MODIFICATION RECOMMENDED - CORRECTS MANUFACTURING OR DESIGN DEFECTS

6684A-07

SERVICE NOTE

6684A DC POWER SUPPLY

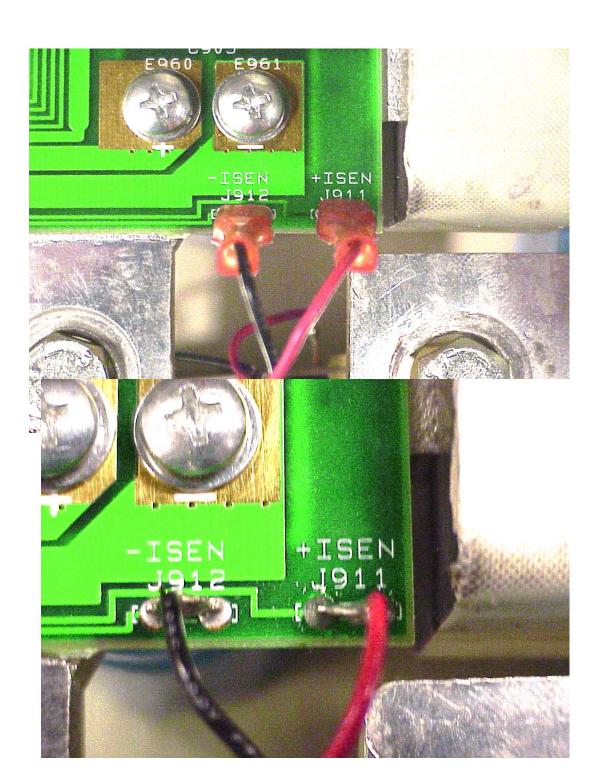
The Current Shunt (Circuit Reference "R900") may have intermittent sense wires, which may cause Instability of Current Regulation, Current read back and current programming may become unstable.

When the push-on connectors become intermittent the output current will become unstable. Loose push-on connectors can cause the output current to change dramatically. The current can change from any set current, and may go to the maximum rated output current of the instrument.

The first picture below shows how the Shunt "R900" is connected using the term-crimp connectors. The Shunt "R900" is connected to (-ISEN J912 Black wire) & (+ISEN J911 Red wire).

The second and the third pictures show how the Shunt "R900" is connected when soldered.

Cut the terminal-crimp connectors off of both wires and discard the connectors. Make this cut as close to the terminal-crimp connector as possible. Carefully strip the wires to approximately 8mm and solder the wires, and avoid burning the wire insulation and the printed circuit board.

This strip length will be used to solder to the connectors to (-ISEN J912 Black wire) & (+ISEN J911 Red wire). The length of these wires is critical. If the strip length of the wires is too long, the wires may cause a short to adjacent components. If the length of the wires is too short the solder connections may be poor. If replacement of the Red or the Black wire is required the same type and color wire should be used (22 AWG. 300V 105C).

The wires should be connected as shown below. The holes in the male connectors should be used to solder the Red and Black wires to the printed circuit assembly marked (–ISEN J912) & (+ISEN J911). Do not mix the Red & Black wires when making this modification. See picture below for details. The pictures shown below show the required modification.

- 1. Inspect the solder connections to determine the solder joints are acceptable.
- 2. Inspect the printed circuit board to insure the solder joints are acceptable around (-ISEN J912) & (+ISEN J911) connectors.
- 3. The wires that are now soldered to (-ISEN J912 Black wire) & (+ISEN J911 Red wire) MUST be twisted.
